MANDATORY BULLETIN No. SportStar-043a SR R2 SAFETY RELATED

1. CONCERNING: All SportStar airplanes.

2. REASON: Unification of the strength class of the fastening bolts in the

Fig. 1 – Securing the engine against falling

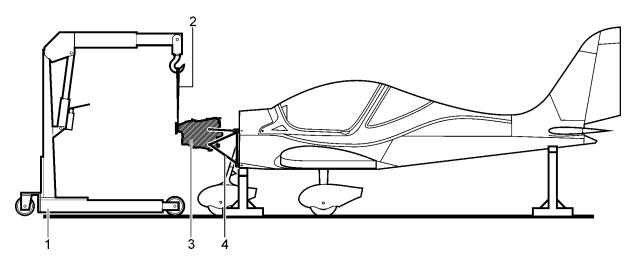
- 1.3.1.7 Remove any hoses or devices that prevent access to the bolts of the engine on the engine mount hinges. In case of removal of one of the hoses, make sure to drain its contents.
- 1.3.1.8 Secure the ends of the removed hoses with suitable plugs against the ingress of dirt.
- 1.3.1.9 Hang the engine (3, Fig. 1) on the workshop crane (1) using the suspension strap (2). The engine (3) is now secured against falling.
- 1.3.1.10 Remove the cotter pins and plugs (5, 7, Fig. 3) from the bolts (1, 2, 3, 4, Fig. 2) in the joint of the engine and the engine mount hinges.

- 1.3.1.21 Release the engine from the mounting crane (Fig. 1).
- 1.3.1.22 Remove all plugs from hoses or devices.
- 1.3.1.23 Attach all hoses which were previously removed to gain access to the bolts.

Fig. 2 – Engine mount – position of fastening bolts

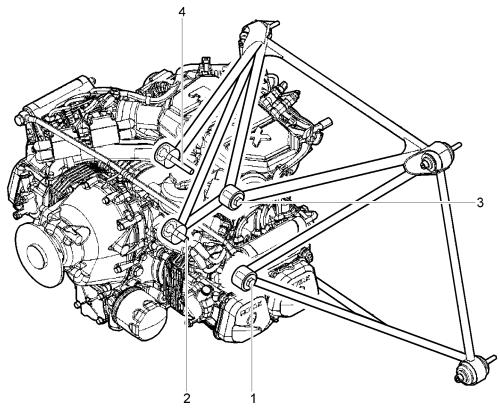
- 1.3.1.11 Remove the bolt (1) from the joint of the engine and the engine mount hinges. Immediately replace the removed bolt with **a new** bolt and a **new** washer (6, Fig.3) one and tighten it lightly.

- 1.3.1.12 Remove the bolt (2) from the joint of the engine and the engine mount hinges. Immediately replace the removed bolt with **a new** bolt and a **new** washer (6, Fig.3) and tighten it lightly.

- 1.3.1.13 Remove the bolt (3) from the joint of the engine and the engine mount hinges. Immediately replace the removed bolt with **a new** bolt and a **new** washer (6, Fig.3) and tighten it lightly.

- 1.3.1.14 Tighten the bolt (4, Fig. 2) in the joint of the engine and the engine mount hinges using a torque wrench with a torque of 40 Nm. This bolt is the only one that is not replaced, but the tightening torque value is changed from 35 Nm to 40 Nm.

- 1.3.1.15 Tighten the bolts (1,2,3) in the joint of the engine and the engine mount hinges using a torque wrench with a torque of 40Nm.
- 1.3.1.16 Put the plugs (5, Fig.3) on the bolts (4), (1,2,3,4, Fig.2).

Fig. 3 – Engine suspension

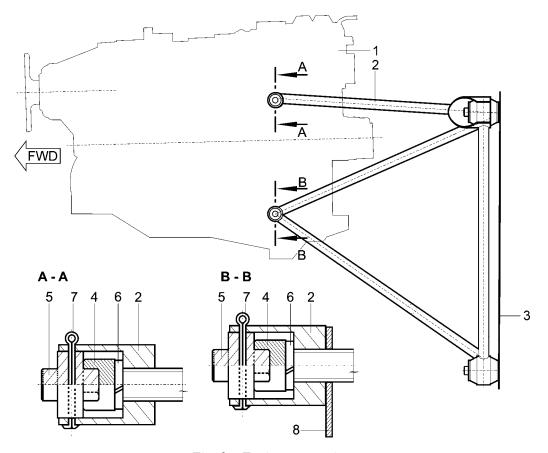
- 1.3.1.17 Mark the plugs (5, Fig. 3) with a marking pin in accordance with the holes in the engine mount hinges (2) on both sides.
- 1.3.1.18 Remove the plugs (5) from the bolts (4) and drill through them with a Ø2,1 mm drill bit in accordance with the marks made by the marking pin.

- 1.3.1.19 Put the plugs (5) back on the bolts (4) so that they align with the holes in the engine mount hinges (2).
- 1.3.1.20 Use the cotter pins (7) to secure the bolts (4) with the plugs (5) in the joint of the engine and the engine mount hinges (2).
